## 2.3 Radiation Monitoring Systems

The information in this section of the ABWR DCD, including all subsections, tables, and figures, is incorporated by reference with the following departures.

Figure 2.3.1 Process Radiation Monitoring System Control Interface Diagram

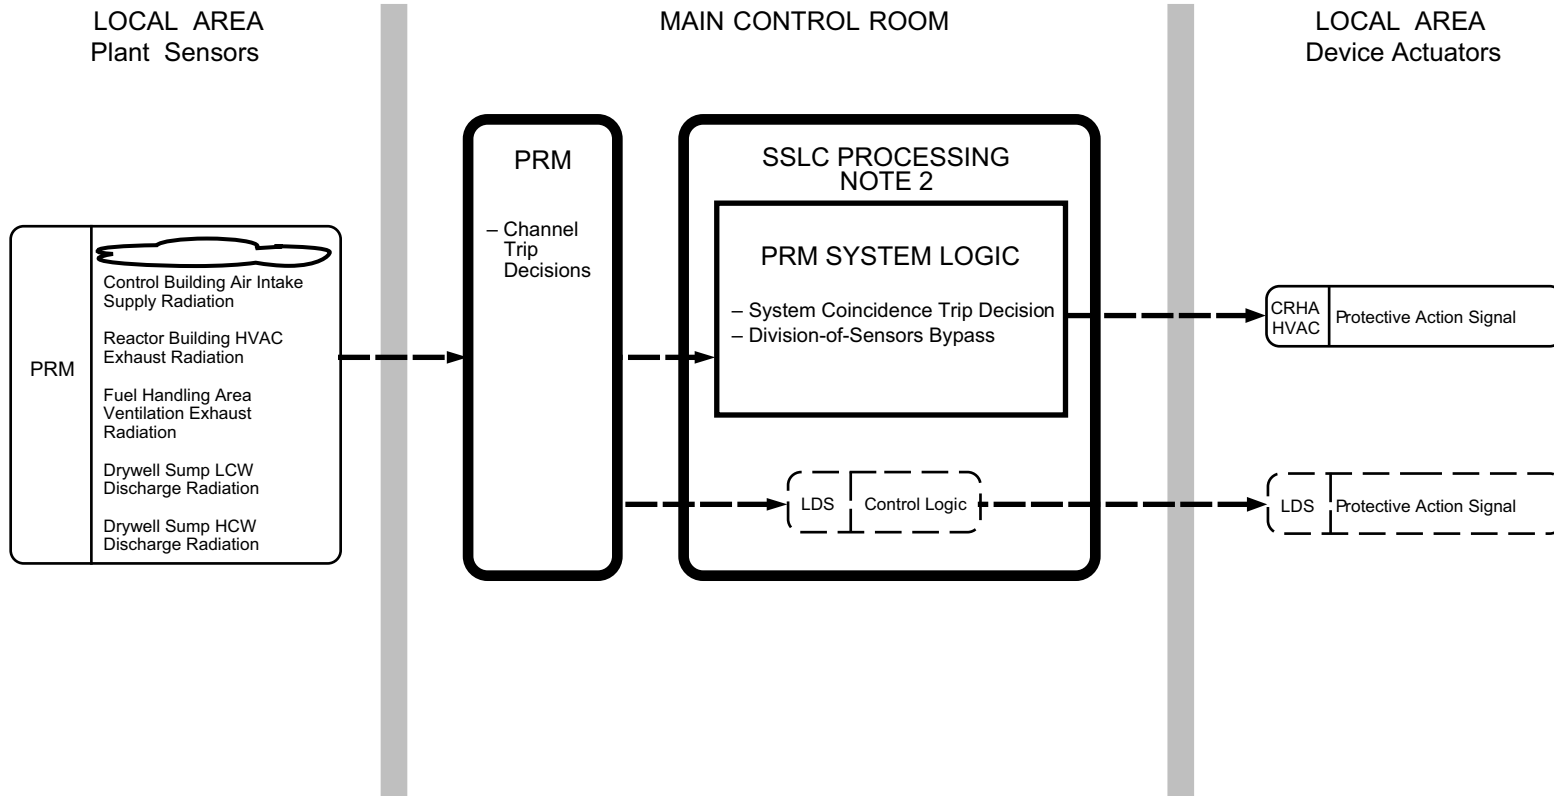
STD DEP T1 2.3-1 (Figure 2.3.1)

STD DEP T1 2.3-1

The Process Radiation Monitoring (PRM) System measures and displays radioactivity levels in process and effluent gaseous and liquid streams. initiates protective actions, and activates alarms in the main control room (MCR) on high radiation signals. The PRM System provides radiological monitoring during plant operation and following an accident. PRM System equipment consists of radiation sensors, radiation process monitors, and effluent samplers. The PRM System consists of independent subsystems each of which contains between one and four monitoring channels. Figure 2.3.1 shows the PRM System control interfaces. As shown on Figure 2.3.1, the PRM System safety-related channel trip signals are provided as inputs to the Safety System Logic and Control (SSLC) for generation of protective action signals.

Portions of the PRM System are classified as Class 1E safety-related (items 4, 2 through 5 below); the remainder are classified as non-safety-related.
